Re: The Residences at Coleridge Coast; 181-183 Coleridge Street, East Boston, MA
Notice of Intent # 006-1606

On behalf of Rock Development (the "Applicant"), we are submitting the following additional information requested at the January 9, 2019 hearing in regard to the updated Notice of Intent (NOI) that was filed on December 5, 2018 for the Residences at Coleridge Coast (the "Project") located at 181-183 Coleridge Street, East Boston, Massachusetts (the "Project Site").

SHEET TITLE:
**COASTAL BANK
 DELINEATION
 PLAN - POSTDEV**

SHEET NUMBER:
POST-01

Figure 4

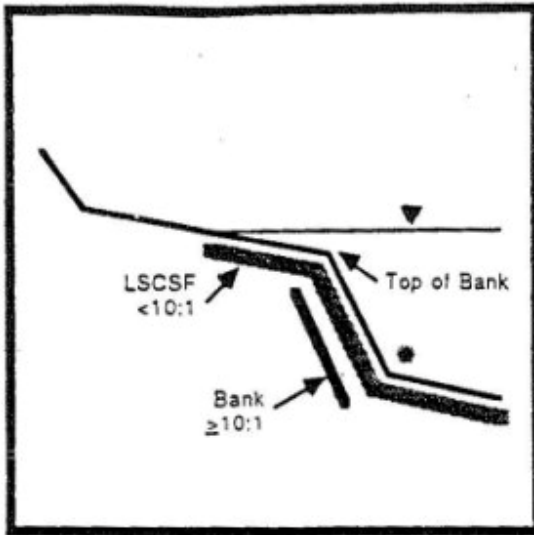
1. Existing Top of Coastal Bank Delineation

We have modified the existing cross-sections to be to scale and have provided a graphical representation of the sections to match Wetlands Program Policy 92-1: Coastal Banks ("Policy 92-1"). The Coastal Bank location remains unchanged. Please note, all Coastal Bank delineations for existing conditions falls within the definition of "Figure 4" of Policy 92-1.

Figure 6

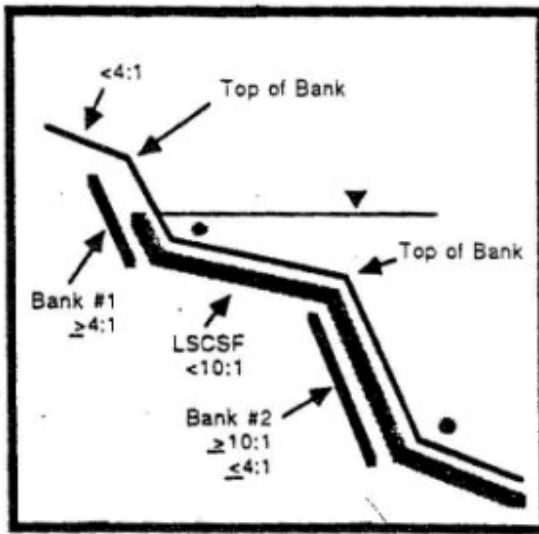
2. Does the proposed conditions create a "new" Coastal Bank?

We have further reviewed Policy 92-1 guidance on Coastal Bank delineations. We concur that the proposed conditions created may in fact create a topographic site condition that would fall under the definition of "Figure 6" and thus introduce a second Coastal Bank. We have shown the "Figure 6" condition on the proposed sections.
